# Access Compliance Report

## Public Rights-of-Way

### (Curb Ramps)

Intersection ID: 10014519	Main Street: UNIVERSITY_POINTE_BV	Cross Street: N/A	Location: NE
ADA ID: 62AD017CEE6A	Ramp Type: Perp	Initial Pass/Fail: Fail	Overall Compliance: No
Severity Score: 21.25			
Codes/Mitigation Info/Possible Solution		Field Measurements/Component Compliance

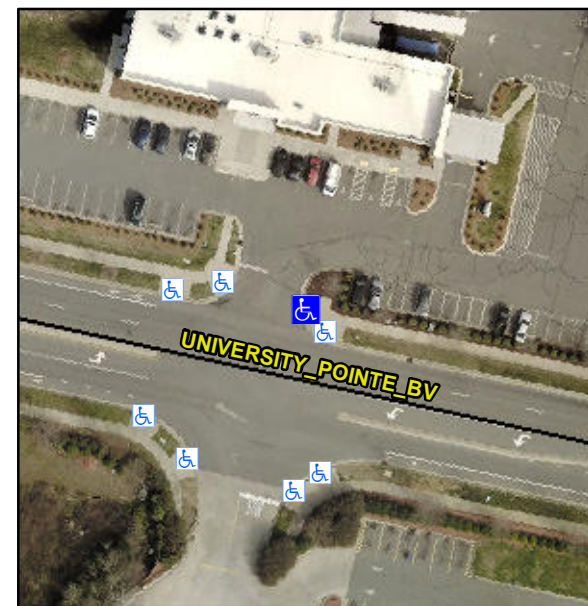
**Not Found, R304.5.1, R304.2.2**

Compliance	Description	Data	Compliance	Description	Data
N/A	Ramp Length (in)	91.0	No	Ramp Slope (%)	9.0
No	Ramp Width (in)	47.0	Yes	Ramp XSlope (%)	1.1
N/A	Flare Type LT	N/A	N/A	Flare Type RT	N/A
N/A	Flare Slope LT (%)	N/A	N/A	Flare Slope RT (%)	N/A
N/A	Flare Traversable LT?	N/A	N/A	Flare Traversable RT?	N/A
N/A	Landing Length (in)	N/A	N/A	DWS Provided?	N/A
N/A	Landing Width (in)	N/A	N/A	DWS Contrast?	N/A
N/A	Landing Slope (%)	N/A	N/A	DWS Length (in)	N/A
N/A	Landing X Slope (%)	N/A	N/A	DWS Full Width?	N/A
N/A	Landing Curb? (Y/N)	N/A	N/A	DWS Offset (in)	N/A
N/A	Shared Landing?	N/A			
N/A	Gutter Ponding?	N/A	N/A	Gutter Slope (%)	N/A
N/A	Gutter Lip Ht (in)	N/A	N/A	Gutter X Slope (%)	N/A
N/A	Painted X Walk1?	No	N/A	Painted X Walk2?	N/A
	X Walk 1 Direction	To W		X Walk 2 Direction	N/A
N/A	X Walk 1 Width (in)	N/A	N/A	X Walk 2 Width (in)	N/A
	X Walk 1 Slope (%)	3.3		X Walk 2 Slope (%)	N/A
	X Walk 1 X Slope (%)	2.6		X Walk 2 X Slope (%)	N/A

**Remove & Replace Entire Ramp.**
